**Department of
Transportation**
transportation.ohio.gov

Project 23-3008, PID 117955, FAY-435-1.52
Dispute No. 06-233008-01
Step 3 – Cracked Concrete Pavement

This letter is in response to John R Jurgensen Company's Step 3 claim paper that was submitted to The Department on June 15th, 2026.

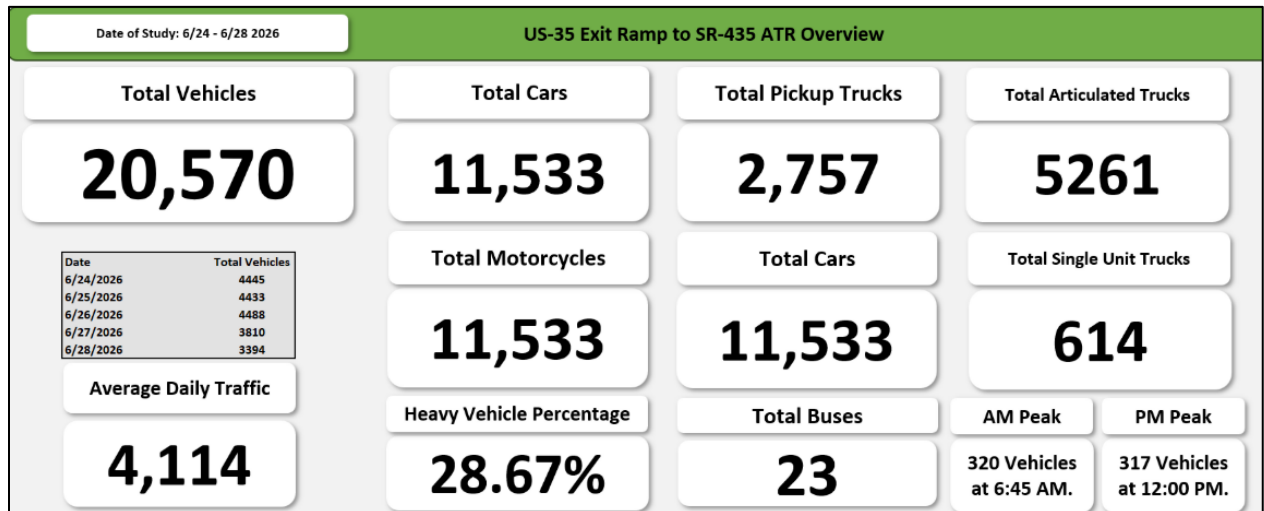
In addition to the scope traffic study, ODOT collected 24-hour weekday (1/15/2026) and weekend (1/17/2026) counts to better understand existing traffic volumes. The weekday ADT (2143 PA & 1382 BC) greatly exceeded the weekend ADT (2019 PA & 716 BC) and therefore it can be used as a conservative representation of the existing ADT. The existing ADT as of January 2026 is less than the opening ADT (2926 PA & 1314 BC) used in design. Note that the opening year ADT used in the design was intended for year 2024. With a 2044 design year, it is anticipated that the traffic would increase linearly by $[1/20 \times (\text{design year ADT} - \text{opening year ADT})]$ each year throughout the 20-year service life of the pavement. This would result in a 2026 traffic volume of 4544 ADT (3135 PA & 1409 BC), accounted for in the design.
